RE: City of Denton Contract Number #5753

The City of Denton requests your immediate attention, response, action, and ***timely resolution*** in regards to completion of the construction work mutually agreed to with Contract #5753 – Construction of the Denton City Airport Hangar Project.

PARTIAL DRAFT PUNCH LIST  
DENTON AIRPORT HANGARS  
February 25, 2016

COMPILED PUNCH LIST  
DENTON AIRPORT HANGARS  
May 26, 2016

#### INTERIOR REVIEW

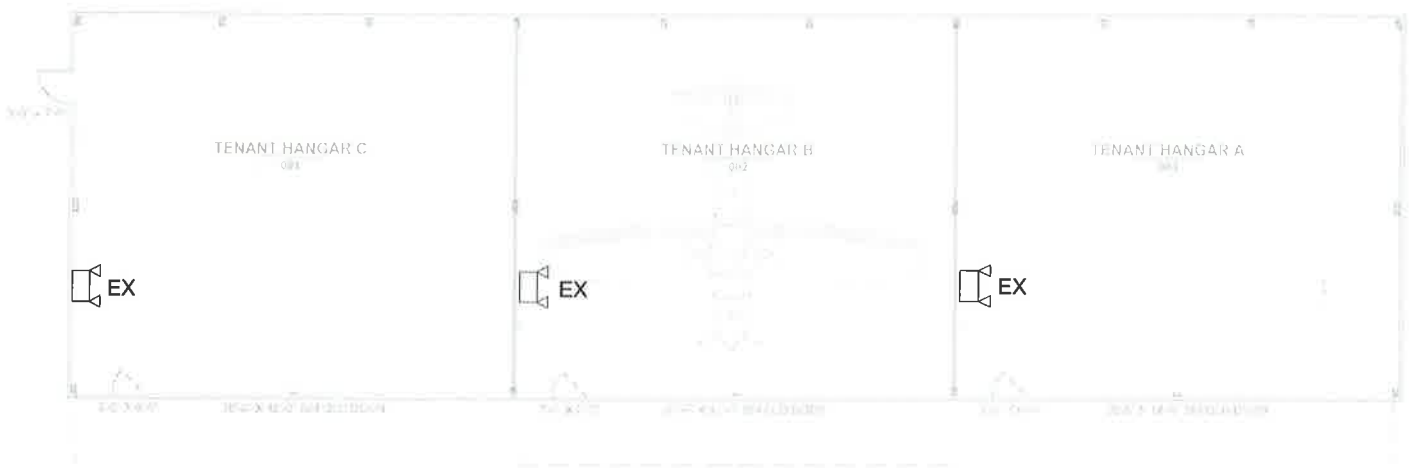
Key	Description
I 4	Spacer washers not installed. One set per all bifold door.
I 5	Door popper plates not installed. Refer to door book.
I 6	Door popper runners to be fasten to frame
I 8	Daylight showing at eave line
I 12	Day light around walk door frame
I 15	Over tighten left cable. Spring is fully compressed in closed position.
I 17	Daylight for endwall apex. Install peak cap boxes
I 27	Missing tek screw
I 28	Tie rod found on floor
